**Measurement of the  $B^-$  and  $\bar{B}^0$  Meson Lifetimes  
Using Semileptonic Decays with Single Lepton Datasets  
in CDF Run II  
(CDF 7458)**

Feb-24 2005 @ B meeting  
S. Uozumi, F. Ukegawa

**— Blessing (continuation) —**

**Issue 2: Why do the  $p_T(\mu^- D^0)$  distributions disagree between the data and MC?**

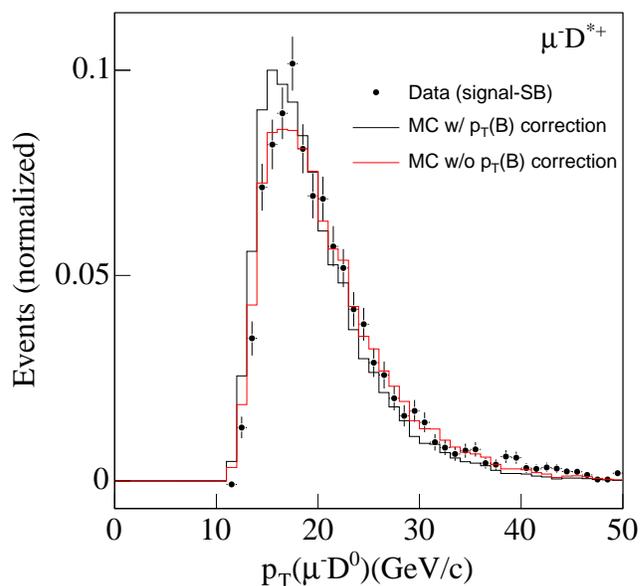
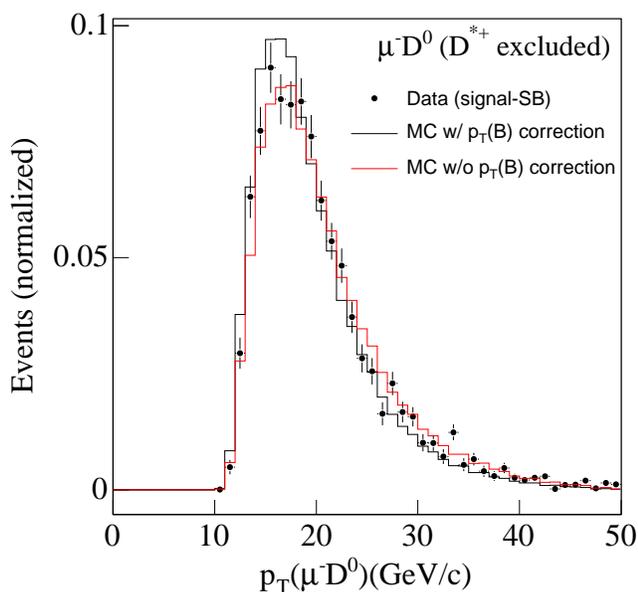
**And does the  $p_T(B)$  spectrum tuning with the B monte carlo look resonable?**

**A : MC distributions were not quite complete.**
